South Carolina Building Codes Modifications Index

Introduction to 2024 Building Codes Modifications Index

2024 SOUTH CAROLINA BUILDING CODES MODIFICATIONS INDEX

Code Section: Figure R327.1 Minimum Fixture Clearances

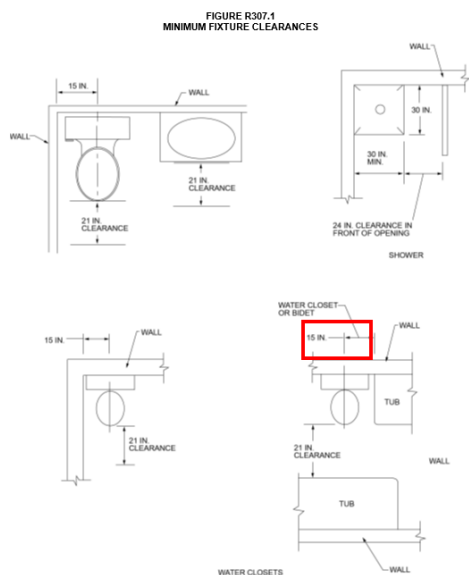
Change the minimum dimension for the side clearance between bathtubs and water closets or bidets from 15 inches to 12 inches.
